PZ&B Staff Combination Memorandum: Landmarks Preservation Commission and Town Council

SUBJECT: ZON-24-0043 (COA-24-0018) 100, 101, 102, and 103 FOUR ARTS
PLZ—SOCIETY OF THE FOUR ARTS

ZON-24-0043 (COA-24-0018) 100, 101, 102, AND 103 FOUR ARTS PLZ—THE SOCIETY OF THE FOUR ARTS (COMBO)—SPECIAL EXCEPTION WITH SITE PLAN REVIEW AND VARIANCE.

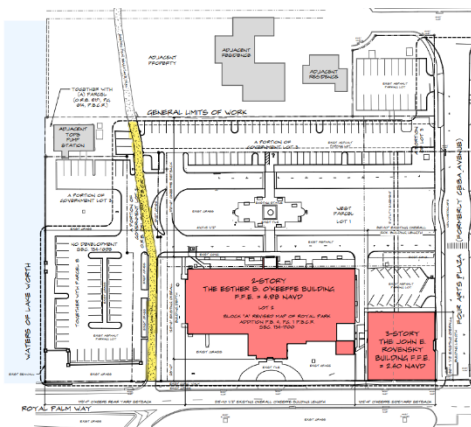
Variance #1 is to reduce the required parking spaces. Currently, the campus as a whole accommodates parking for 274 vehicles, which is nonconforming as it pertains to the required

parking for the uses. The existing theater accommodates 714 seats which requires 179 parking spaces (1 parking space for every 4 seats). The existing 17,035 square-foot professional office use area requires 68 parking spaces (1 parking space per 250 square feet). The 5,525 square foot museum use area requires 11 parking spaces (1 parking space per 500 square feet). The library encompasses 4,812 square feet which requires 10 parking spaces (1 parking space per 500 square feet). The total required parking for the existing campus is 268 parking spaces.

- Theater: 656 seats (1 parking space per 4 seats), requires 164 parking spaces
- Professional Office: 31,526 square feet (1 parking space per 250 square feet), requires 126 parking spaces
- Museum: 5,186 square feet (1 parking space per 500 square feet), requires 10 parking spaces
- Library: 7,800 square feet (1 parking space per 500 square feet), requires 16 parking spaces
- **Total Required Parking: 316 spaces**

The variance request currently seeks to reduce the parking to 233 spaces, representing a reduction of 83 spaces (26%). A parking study by Kimley Horn was submitted that presents parking demand for visitors and employees. The study concludes that *“Accounting for variations in time-of-day demand for uses on site, the peak parking needs for the campus are anticipated to be approximately 232 spaces during the weekday peak period in which the theater is in use. Therefore, the parking needs for the site are anticipated to be met.”*

The Town’s code does not offer alternate parking requirements based on parking demand calculations.

Proposed Trail

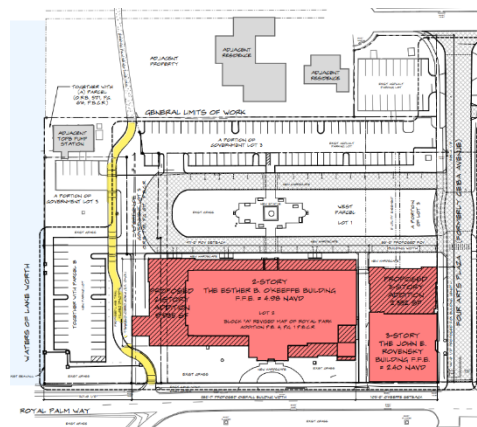
As previously mentioned, the existing Lake Trail right-of-way traverses the west campus towards the western side of the site. To accommodate the proposed additions to the O’Keeffe building, the application seeks to abandon this easement to reconfigure the pedestrian path slightly to the west. The formal abandonment and new dedication will be processed separately, however, is it recommended that it be discussed during the site plan review since it impacts the proposed configuration of the site (and possibly additional parking space loss). A general consensus for the direction of the application as it pertains to the relocation of the Lake Trail would be appropriate.
